METROPOLITAN GOVERNMENT OF NASHVILLE AND DAVIDSON COUNTY

Metropolitan Historic Zoning Commission
Sunnyside in Sevier Park
3000 Granny White Pike
Nashville, Tennessee 37204
Telephone: (615) 862-7970
Fax: (615) 862-7974

STAFF RECOMMENDATION
722 & 726 McFerrin Avenue
January 20, 2021

Application: New Construction - Infill
District: Maxwell Heights Neighborhood Conservation Zoning Overlay
Council District: 05
Base Zoning: MUN-A
Map and Parcel Number: 082080287.00 & 082080286.00
Applicant: Brandon Williams
Project Lead: Jenny Warren, jenny.warren@nashville.gov

Figure 8: Elevation along Cleveland Street

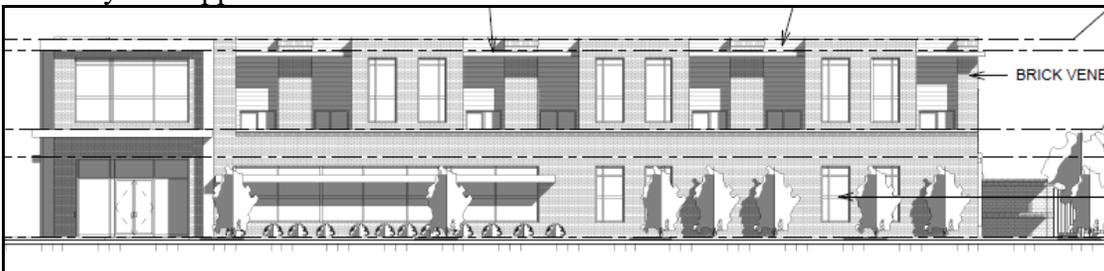
The applicant is proposing to construct a building with a commercial form on these commercially zoned lots. (Figure 7) Staff finds that this form is appropriate to the immediate corner commercial context. Maxwell Heights is a residential neighborhood that contains primarily one and one-and-a-half story homes. This corner contains the only commercial forms in the district, and a flat roof is appropriate here. Because the adjacent historic context along McFerrin Avenue is one and one-and-a-half story houses with pitched roofs, staff has requested that the height of the development taper down to one story as it approaches this context.

The new construction is proposed to be twenty-seven feet, six inches (27'6") tall from grade at the front corner. At the busy commercial corner, staff finds that this height could be appropriate. The contributing commercial structure diagonally across the street (Figure 6) is about seventeen feet (17') high, but staff finds that the proposed height of the new construction should not overwhelm this historic property, due to the distance across the intersection. (Figure 4)

Figure 11. Proposed site plan

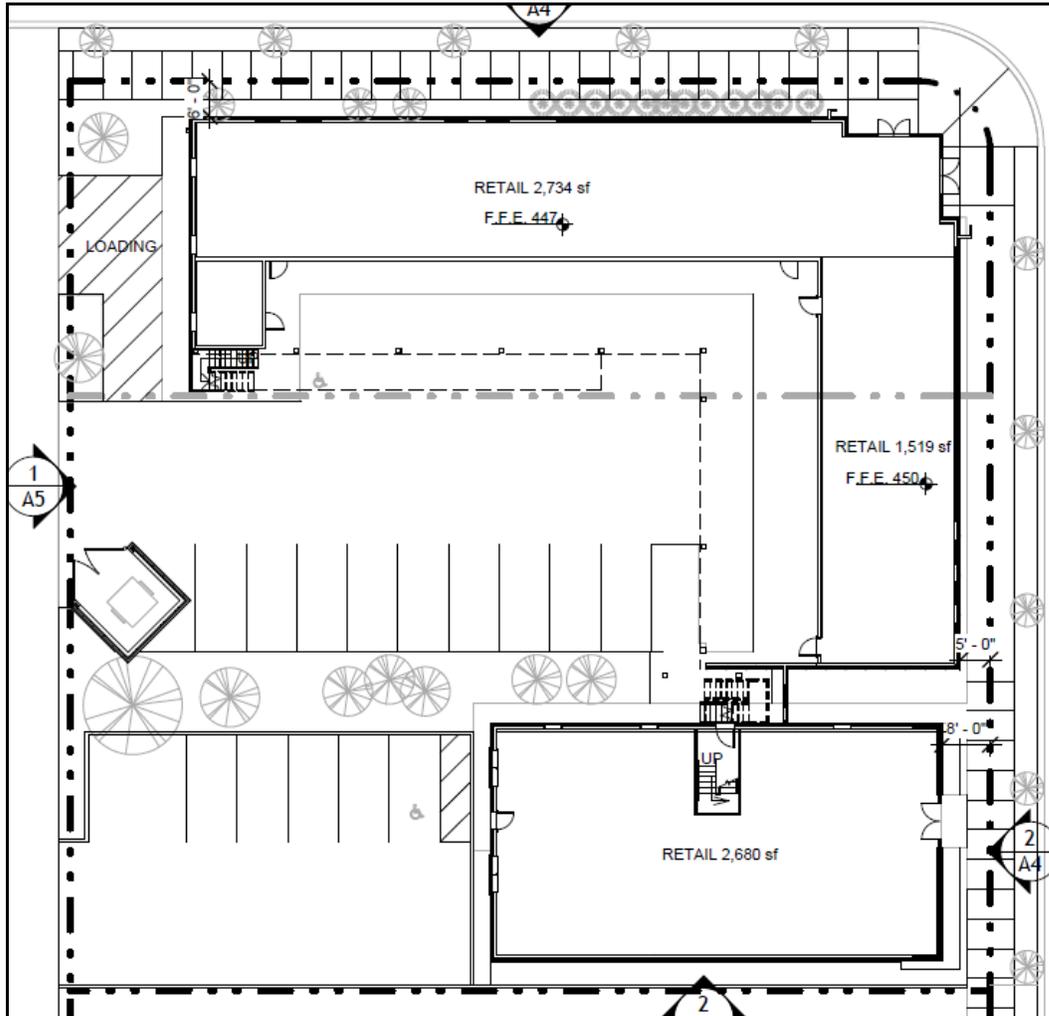
The site plan shows the building set back six feet (6') from the Cleveland Street property line and five feet (5') from McFerrin Avenue. The portion of the building that sits closest to the houses on McFerrin steps back further to be eight feet (8') from the property line. Commercial forms typically sit close to the sidewalk. In this case, with residential forms making up the rest of the block and having approximately twenty-three foot (23') setbacks, staff finds that it is appropriate to step back this portion further from the sidewalk to transition into the residential setback.

Staff has expressed concerns to the applicant that they may need to provide a full sixteen feet (16') from the street to the front wall of the structure, to allow for sidewalk requirements. *According to Planning's Community Transportation Plans map, McFerrin Ave and Cleveland Street have a requirement of a four foot (4') planting strip, an eight foot (8') wide sidewalk and frontage width of four feet (4'). Sidewalk dedication is still required, even if the property qualifies to pay in-lieu-of fees.* However, MHZC does not

review sidewalks and these proposed setbacks meet the design guidelines. If site planning requirements cause alterations to the site plan, the applicant may need to return to the Commission for approval of those alterations.

The site plan proposes a twenty-foot (20') rear setback to the alley, which is appropriate. On the interior, the building is measuring five feet (5') from the side property line along McFerrin, which is appropriate.

Staff finds that the proposed site plan could meet the design guidelines, but again recommends that the applicant confirm details of sidewalk and zoning requirements with the appropriate departments.

Figure 12. Left side elevation along McFerrin

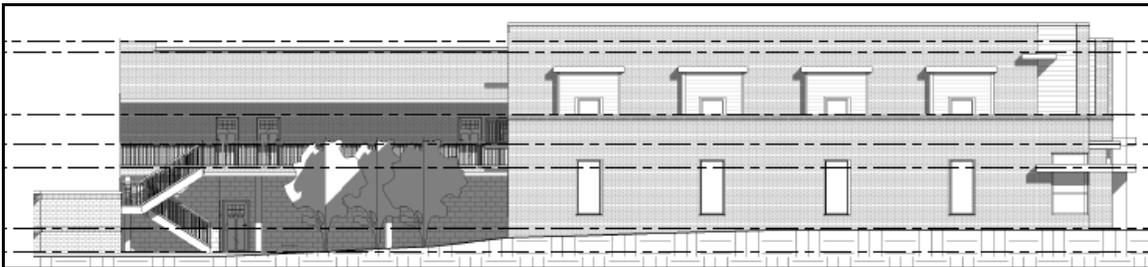
The street-facing and side elevations contain regular openings with appropriate proportions. There are fewer openings along the rear, facing the parking lot, but this is typical for a commercial structure and staff finds it to be appropriate here. The project may be constructed in phases, with the interior portion constructed first. If so, the right elevation of this interior piece will be highly visible. (Figure 13) The applicant provided an elevation of how this side will look should it be built as a separate phase. This elevation has an appropriate rhythm of openings. The project's proportion and rhythm of openings meets Section II.B.1.g.

2 Elev at McFerrin Ave

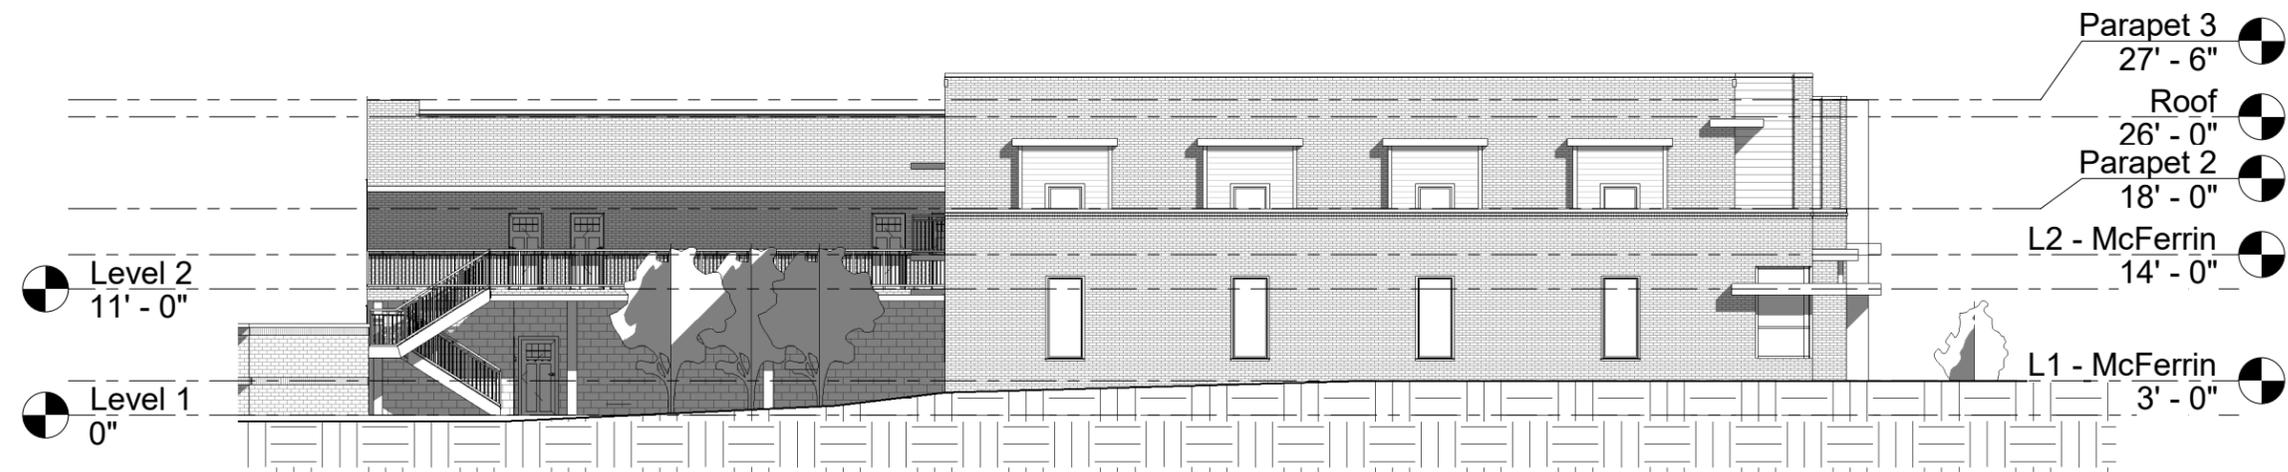
The grade slopes up along McFerrin, away from Cleveland Street and into the residential part of the neighborhood. The project bumps up in the last few bays to regain some of the height lost to grade, but the total maximum height from grade at this location remains lower than the corner, at about twenty-six feet, ten inches (26'10").

While two-stories could be appropriate for at least a portion of this corner, staff asked the applicant to provide a transitional height on the south end of the McFerrin Avenue elevation to help this design step down to meet the heights of the one and one-and-a-half story houses with pitched roofs along this street. (Figure 10) Where it abuts the neighboring property, the development has a seven foot (7') wide one-story section that is about fourteen feet (14') tall and has a flat roof. This is followed by a nine foot (9') wide section where the second floor is recessed before the second level steps flush with the ground level. These design elements – combined with the setback to be discussed below – help to ease the height transition.
